**TOWN OF TRUMBULL
REQUEST FOR PROPOSALS
BLACKHOUSE ROAD CULVERT REHABILITATION**

**RFP: #6303
DUE: June 21, 2018 @ 2:00 PM**

Addendum #2 Dated 6/15/18

FIGURE 1

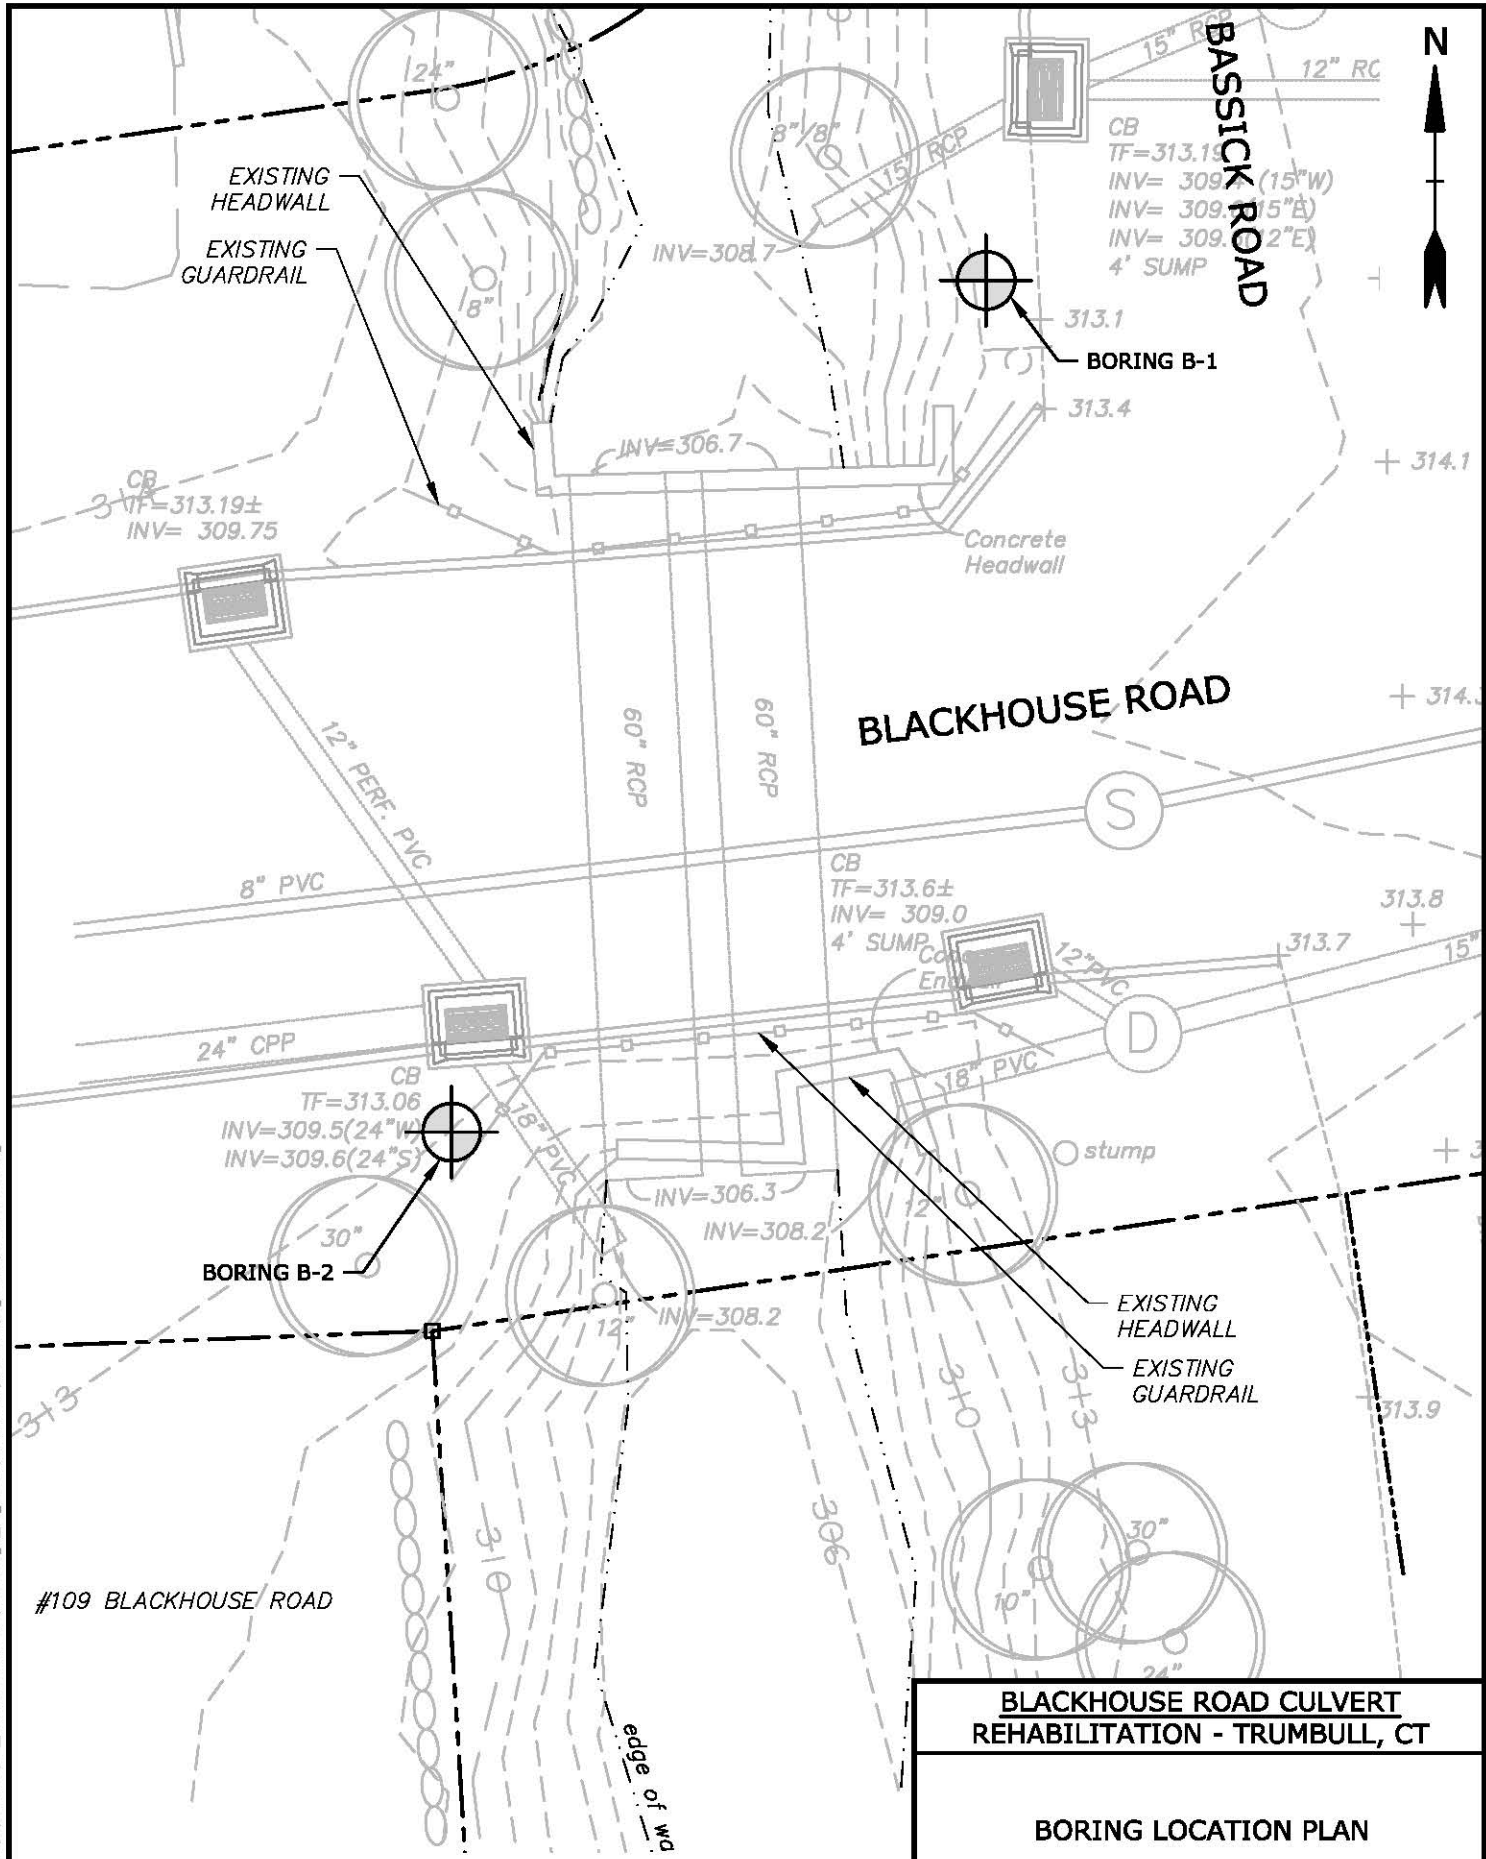
Question 1: Borings 8-1 and 8-2 on Drawing G-1 each state to see Exploration Location Plan. It does not appear that this Exploration Plan is part of the Bid Documents. Please review and advise.

Response 1: See attached "Figure No. 1 – Boring Location Plan".

BLACKHOUSE ROAD CULVERT REHABILITATION - TRUMBULL, CT	
WALL DETAILS	
DATE: JUNE 2018	Tighe & Bond Engineers Environmental Specialists
SCALE: 1" = 4'	
FIGURE 2

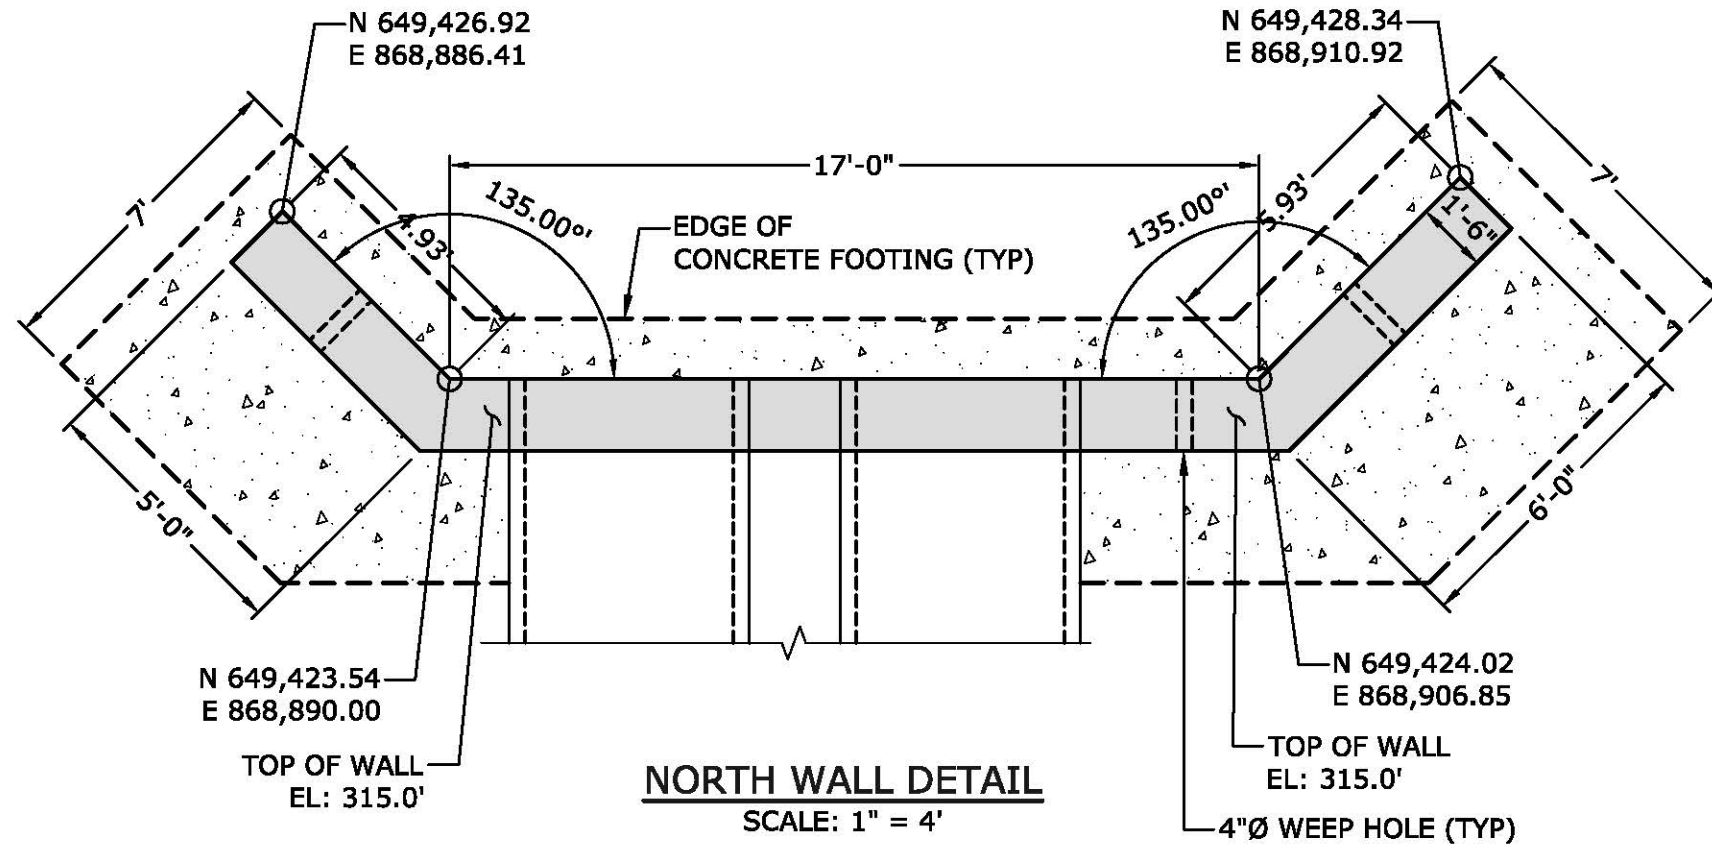
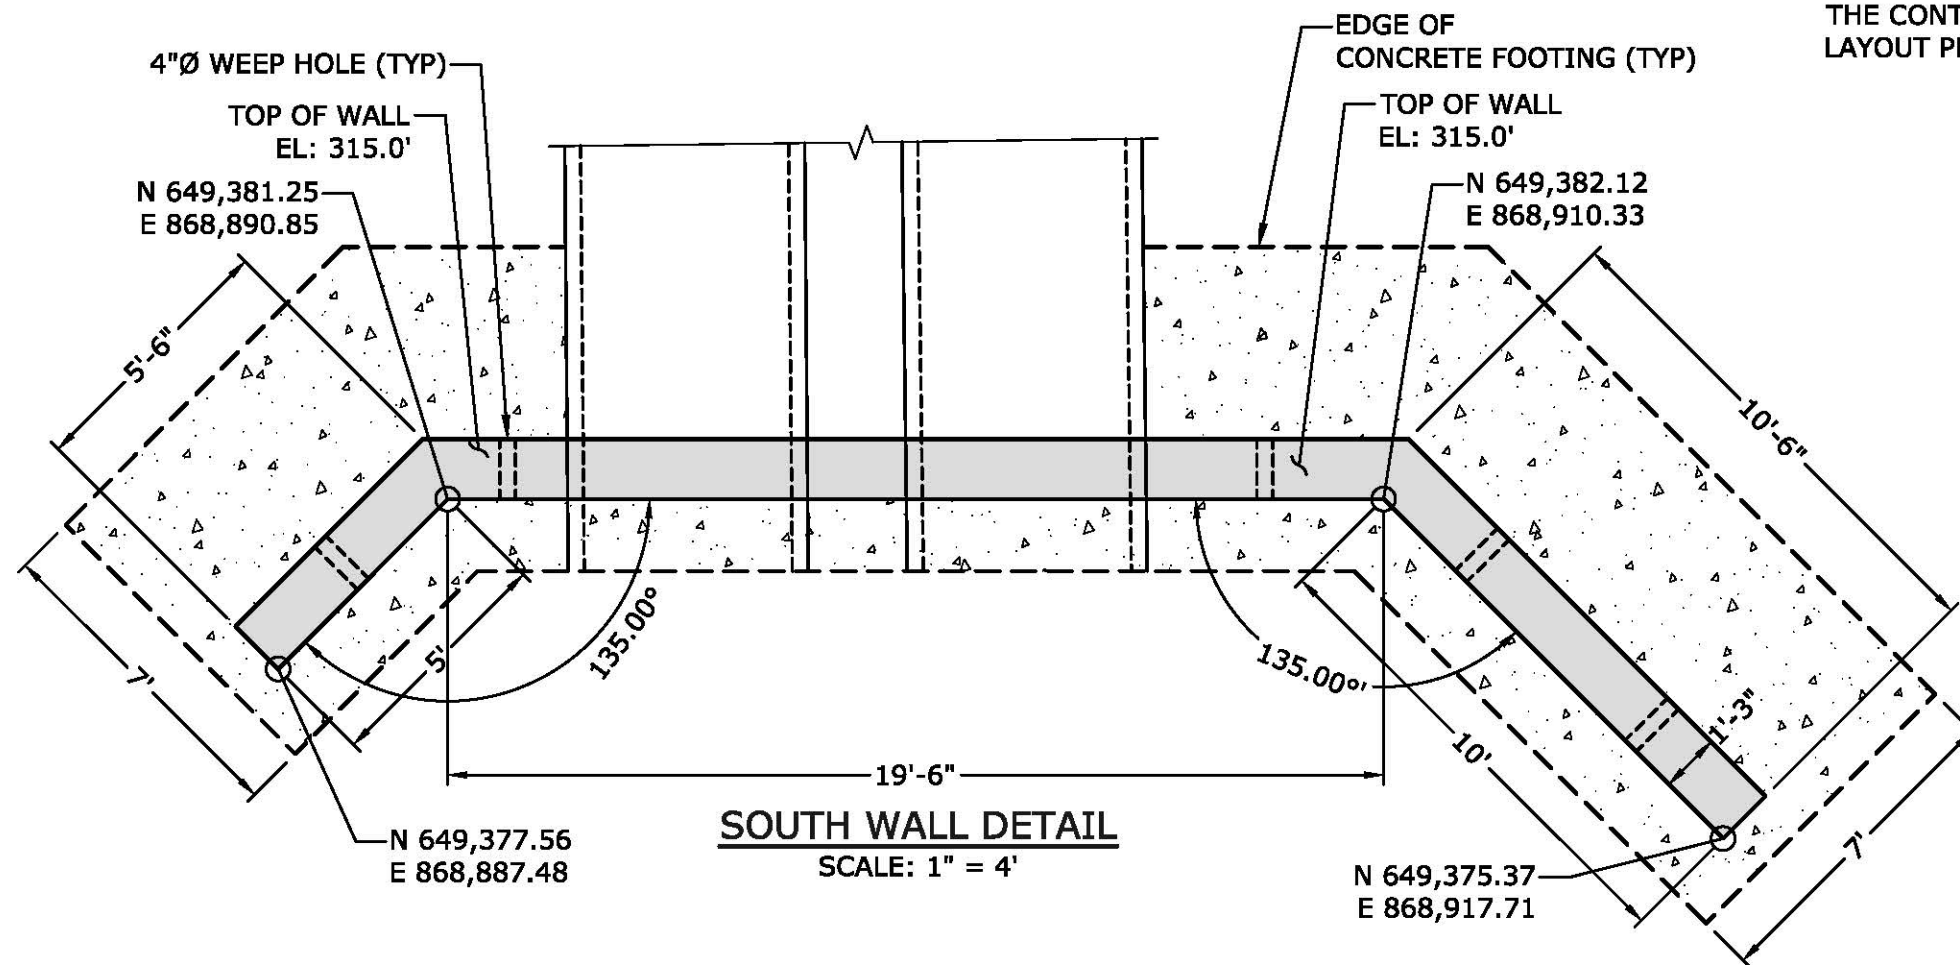
Question 5: The NORTH WALL DETAIL Coordinates on Drawing S-1 do not appear to correlate with the dimensions shown. Also, the Headwall Footing width appears to be less than 6'-9". Please review and advise.

Question 6: The TYPICAL WING WALL SECTION dimensions on Drawing S-2 do not appear to correlate with Wall Details shown on Drawing S-1. Please review and advise.

Response 5: See attached "Figure No. 2. Wall Details".

Response 6: See attached "Figure No. 2. Wall Details".
